TDECQ Reference Equalizer Definition

Addressing comments #187, #171, #172, #173, #174, #175, #176, #177, #183, #184, #185 and #186 against IEEE P802.3dj D2.1

Table 180-15—Reference equalizer tap coefficients

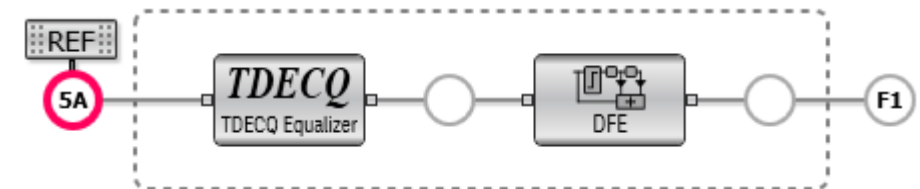
DFE Tap Weight Reference

- FFE taps are applied directly to the waveform values (volts or watts), so their impact naturally scales if you double the size of the signal.
- The DFE taps get applied to symbol values $[-1, -1/3, +1/3, 1]$ scaled by a fixed amplitude factor (OMA/2), rather than directly to the signal
- This is equivalent to applying the DFE tap to the ideal symbol level: $[-\text{OMA}/2, -\text{OMA}/6, +\text{OMA}/6, +\text{OMA}/2]$.
- Larger signals are unfairly constrained by tap limits compared to small signals if the amplitude factor is left out

Suggested Remedy: Reference the DFE coefficient to OMA/2 measured at the input of the FFE equalizer. Add a footnote to the reference equalizer tap coefficients table.

“The DFE coefficient $b(1)$ is referenced to OMA/2”

Table 180–15—Reference equalizer tap coefficients

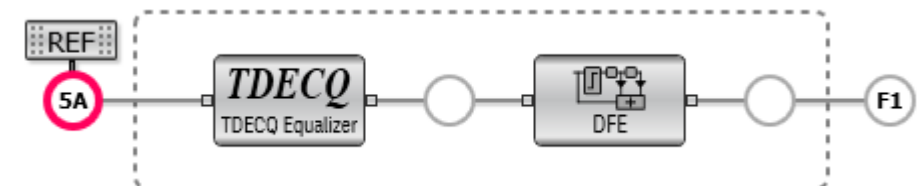
- The pre-post equalizer coefficient limit was added to penalize transmitters with poor group delay variation. Restricting the first pre-post tap difference will keep the phase close to linear.
- The spec does not currently specify what the optimization algorithm should do when the $w(1) > 0$ condition is satisfied which could potentially lead to different answers.

Remove the condition “for $w(1) > 0$ ” to limit asymmetry for all cases

$$|w(1) - w(-1)| < 0.25$$

To address the higher sensitivity when $w(1) > 0$ demonstrated in [chayeb_3dj_01_2505](#), we can use different limits on both sides:

$$-0.3 \leq w(1) - w(-1) \leq 0.15$$

Change the pre-post equalizer coefficient difference limit to “ $|w(1) - w(-1)| < 0.25$ ”
